Box Hill Brickworks Parkland

WHITEHORSE PLANNING SCHEME AMENDMENT C255 SRL-EAST DRAFT STRUCTURE PLAN – BOX HILL

SUBMISSION

4 April 2025

Map 1 to Schedule 5 to Clause 37.10: Use and development framework plan

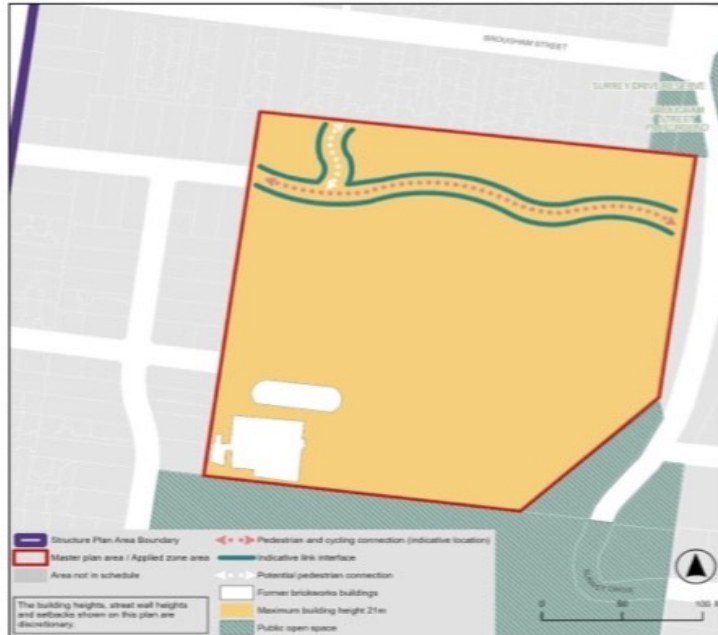
The Framework plan shades the whole site in yellow, with an outline of the Brickwork buildings in white and delineation of an east-west pedestrian and cycling connection.

The **Role of the Precinct** refers to two distinct land uses: residential development and new open space. The ‘Use and development framework plan’ is silent on the ‘new open space’.

The legend has yellow shading: *Maximum building height 21m* with a note to the effect that: *The building heights, street wall height and setbacks shown on this plan are discretionary*.

- A. We submit that planning controls for the Brickworks site must set aside a significant proportion of the site to passive open space. This should involve appropriate revisions to Schedule 5 that include the conceptual delineation of the new open space on Map 1 (Use and development framework plan). This should be guided by the analysis provided in this submission.

Parkland and Development Zone (Scenario 1)

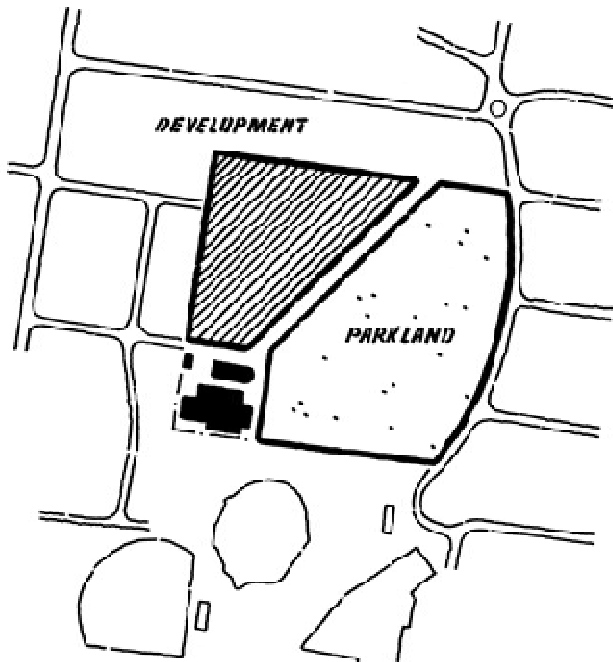
This diagram demarcates the proposed parkland and the future development area according to the 'Artist impression of Box Hill in the future' perspective drawing on P.30 of the SRL East Draft Structure Plan document.

In this scenario, the propositions outlined in Part B are fulfilled.
